Field campaign

Topic	Bentayga - Control Unit for Fuel Pump (SC 20/05)
Market area	China 796 VW Import Comp. Ltd (Vico), Beijing (6796),United Kingdom E01 Bentley UK (6E01),United States E05 Bentley USA and rest America (6E05)
Brand	Bentley
Transaction No.	2058764/2
Campaign number	EB47
Note	
Type	Field Campaign
US code

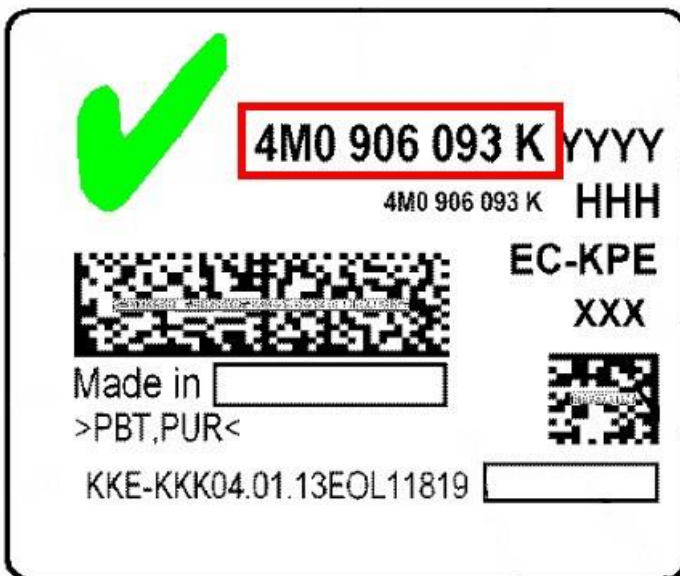
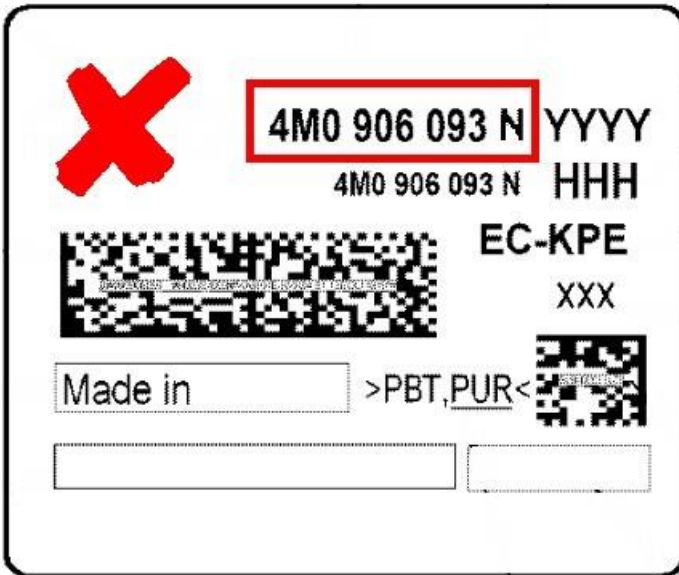
Check the part number marked on both fuel pump control units, refer to *Repair Group 20 Fuel supply, gas operation – 6.0L W12 TSI – Fuel pump control units (J538, J835) – To remove and fit.*

Check the part number marked on the fuel pump control unit, refer to *Repair Group 20 Fuel supply, gas operation – 4.0L V8 TSI – Fuel pump control unit (J538) – To remove and fit.*

If the part number on the fuel pump control unit(s) is 4M0 906 093 N or the control unit cannot be identified, proceed to replace with control unit 4M0 906 093 K. Should the original control unit(s) be identified as 4M0 906 093 K no further action is required.

Note: It is possible on 6.0L – W12 vehicle variants there may be a mixture of 4M0 906 093 K and 4M0 906 093 N control units, only the “ N” level fuel pump control units should be replaced.
